Preapplication Safety Evaluation Report for the Power Reactor Innovative Small Module (PRISM) Liquid-Metal Reactor

Final Report

**Office of Nuclear Reactor Regulation
U.S. Nuclear Regulatory Commission
Washington, DC 20555-0001**

Figure 5.8 PRISM EM pump coastdown flow

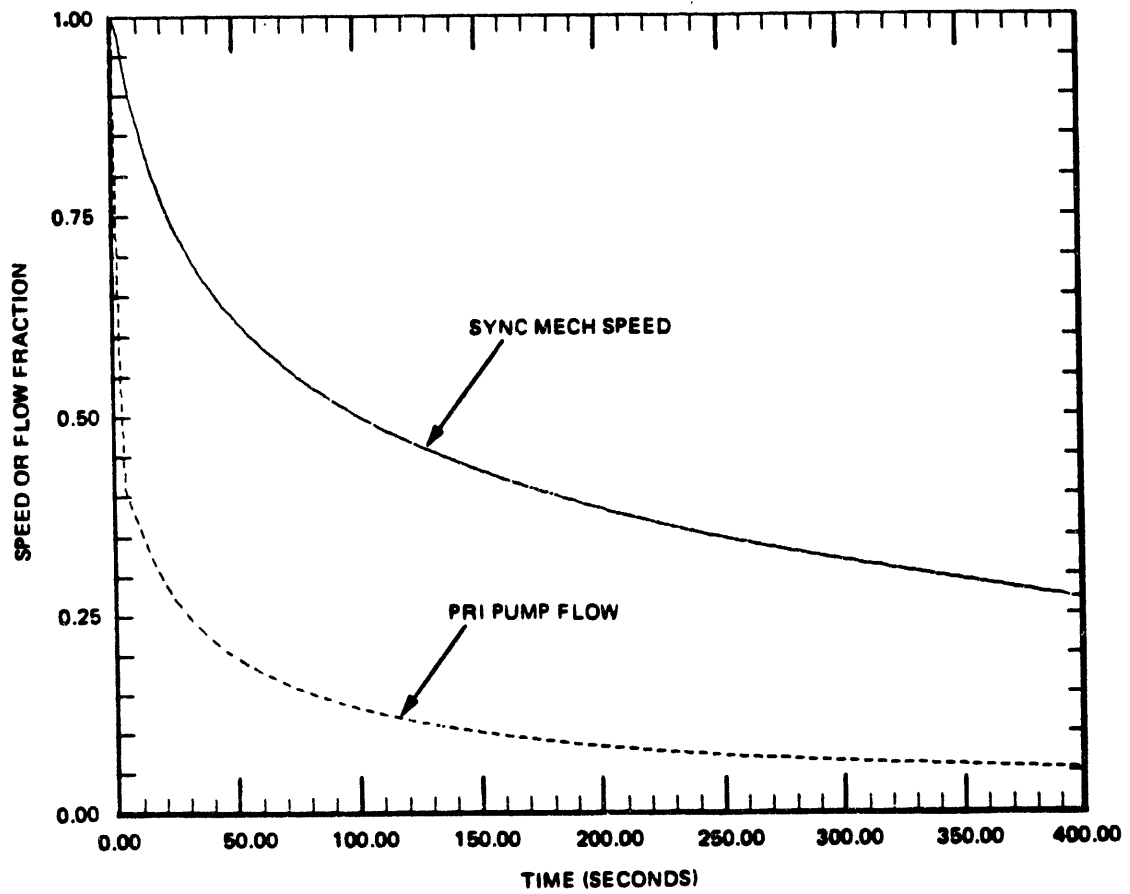
The synchronous machine flywheel and rotor are designed to provide at least the coastdown characteristics shown in the pump coastdown curve (Figure 5.8). The coastdown curve given by the designer has been verified independently by BNL in studies initiated by the NRC staff, and the designer will also experimentally be

Figure 5.13 Alternative flow model for blockage of RVACS inlets

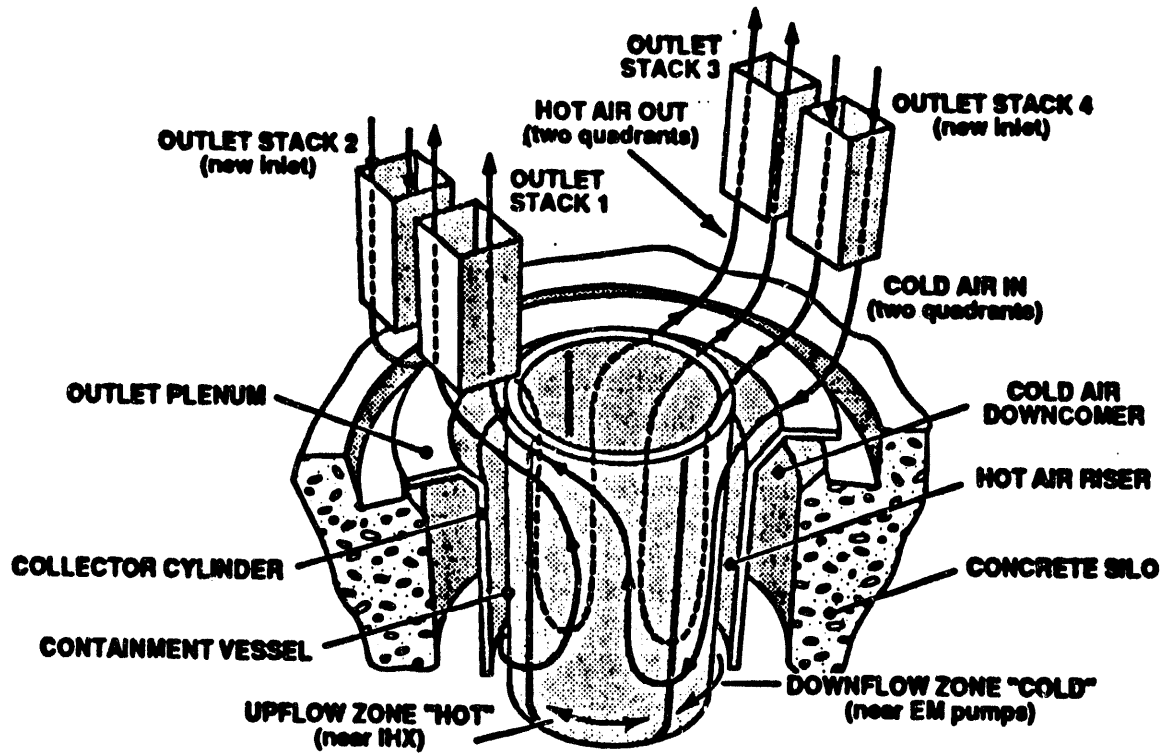
For a blockage of just the inlets, an alternative method of heat transfer becomes important. This method is shown in Figure 5.13. In this case, two of the four outlets would become inlets. Air would still circulate by natural convection; however, air would circulate downward near the cool sodium of the EM pumps, and would rise near the hotter sodium of the IHX. Hence, the two outlets near the EM pumps would become inlets, and the outlets near the IHXs would remain outlets. The designer has stated that maximum temperature at the core outlet would reach 904 K (1168 °F), below Level C limits, and that uncertainties in the analysis might increase this temperature

Figure 15.4 PRISM reactor changes to enhance accident mitigation capability

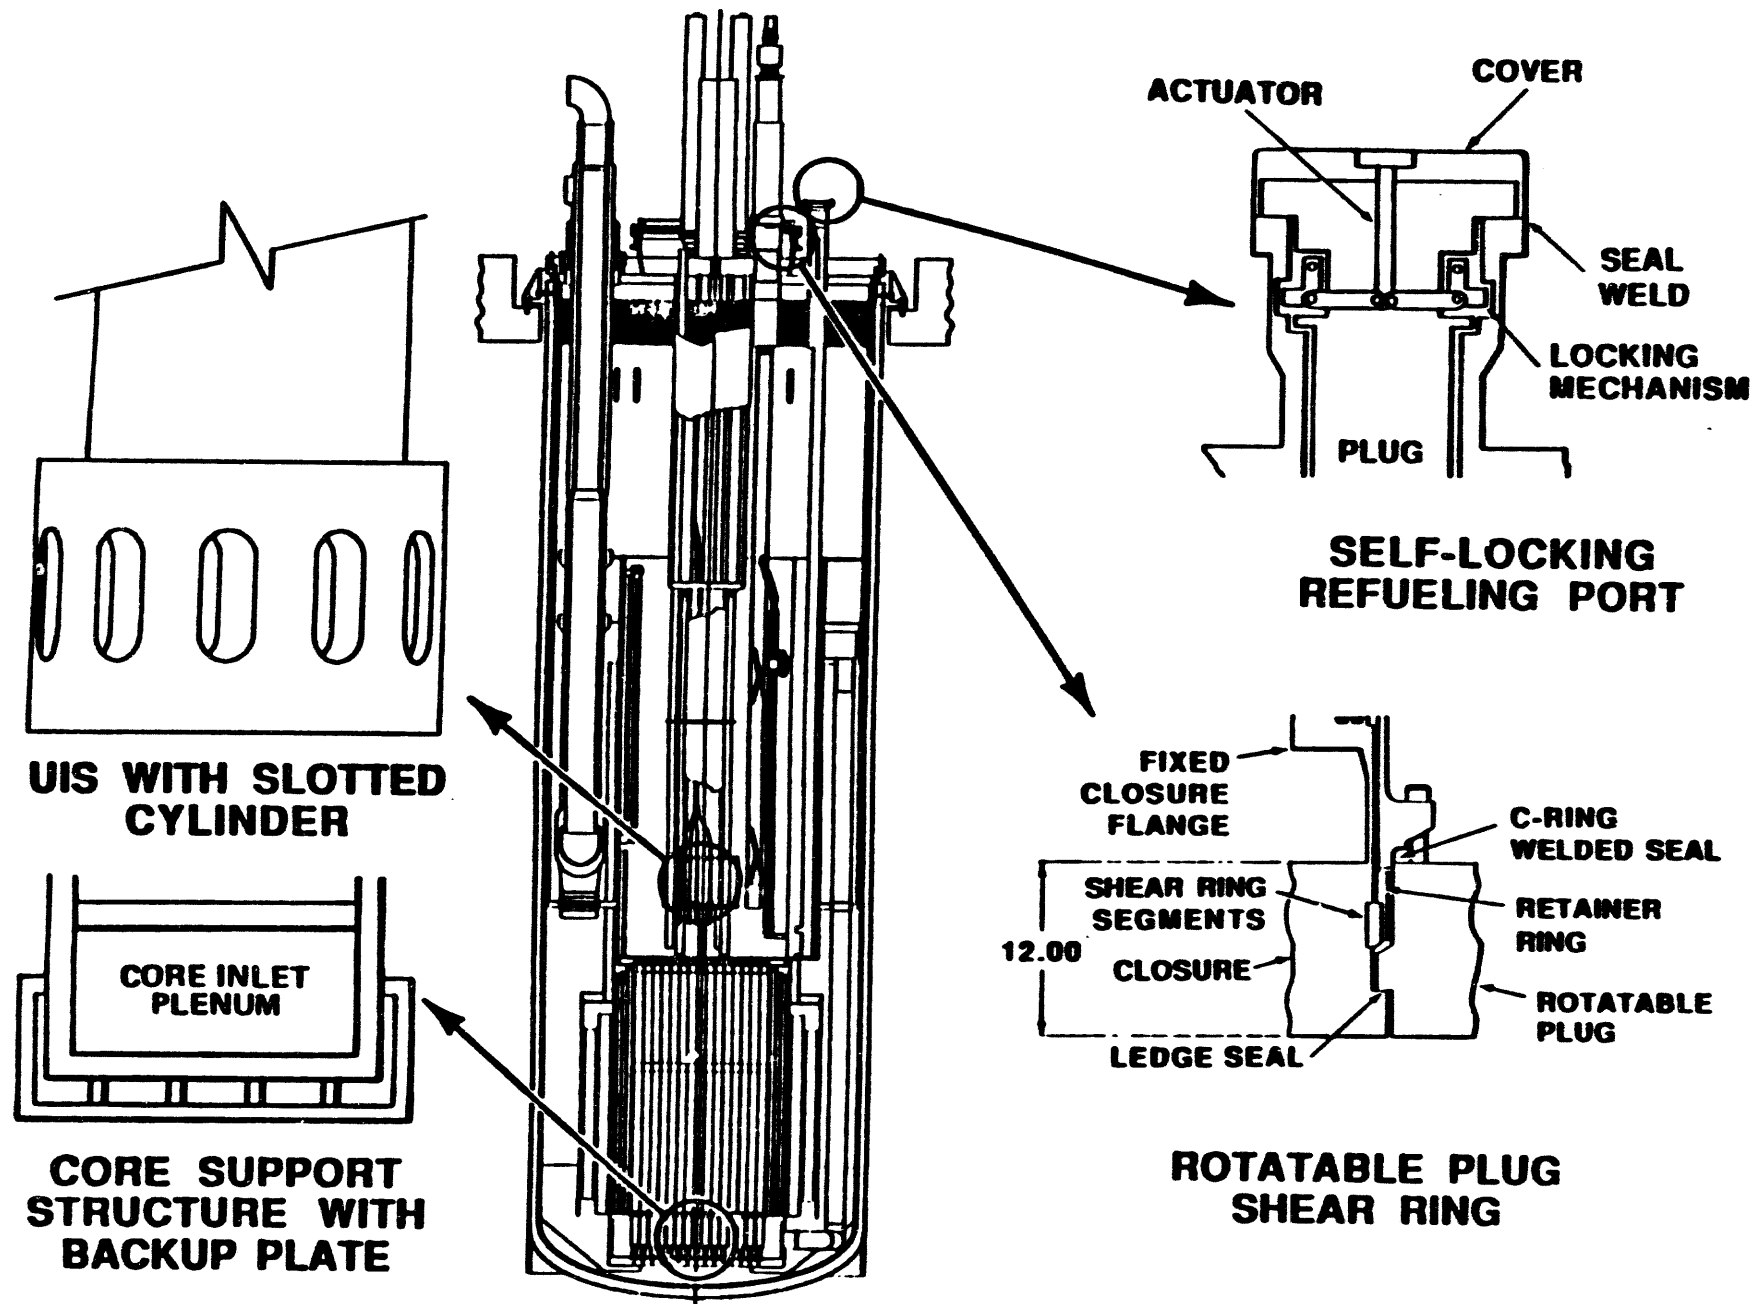
Several design changes are now under consideration to enhance the ability of the reactor to contain the consequences of an HCDA and/or a core melt accident within the primary system boundary. Several specific hardware features, to address HCDA energetics and core melt, under consideration, shown in Figure 15.4, are:

Figure B.2 Summary of GE Bounding Events 1A, 1B, 2', and 4

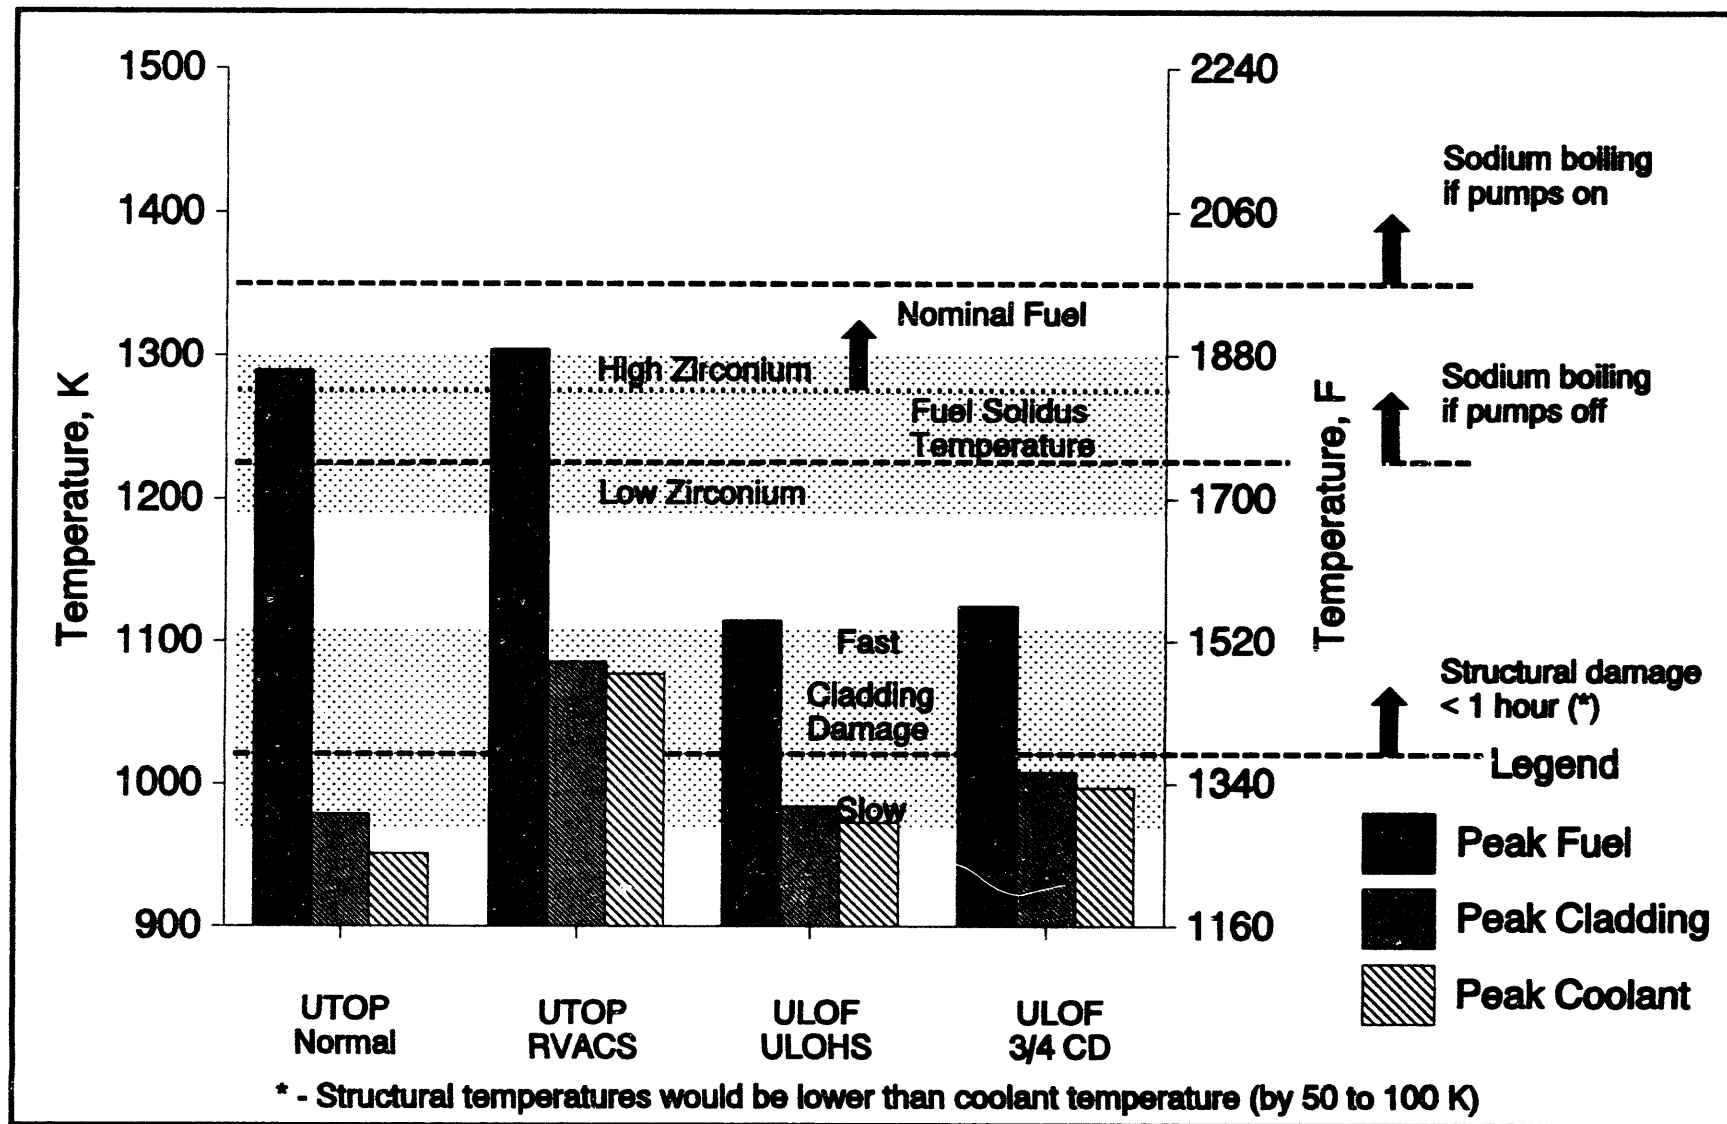
It is clear from Figure B.2 that some fuel would be heated above the solidus temperature for BE-1A and -1B. For the UTOP events, the power production in the pins increases by about 70 percent, so the pin center-line temperatures can increase very substantially. As the peak fuel temperatures for BE-1A and BE-1B are above the solidus temperature for the zirconium fuel, there is little doubt that some localized melting would take place. A decision will be required at the design certification stage, in terms of how much, if any, localized fuel melting will be acceptable.

The ULOF-ULOHS (BE-2') and ULOF-3/4 coastdown (BE-4) events on the right side of Figure B.2 result in significantly lower fuel temperatures. There may be a very slight amount of cladding damage for these events, especially if conservative limits are applied. The sodium is well below boiling, with or without pumping. A major factor in limiting the peak temperatures is the use of the GEMs to insert a large amount of negative reactivity once the pumps trip off line.

The GE results presented in PSID Section G.4.16.2, as summarized in Figure B.2 point directly to the postulated UTOP events as the safety concerns within the category of "bounding events." Independent analyses performed at Brookhaven National Laboratory (BNL) (Ref. B.5) tend to confirm this, although BNL's peak fuel temperatures are somewhat higher, and the subsequent cladding damage greater. Despite ANL's optimism that it can demonstrate that metal fuel can survive these events, GE may have to consider reducing the potential UTOP initiator below 40¢ (including uncertainties), perhaps by moving the control rod stops more frequently. Because the preapplicant seems to have a few options available to reduce the potential UTOP initiators, the results summarized in Figure B.2 are not viewed as an insurmountable problem.
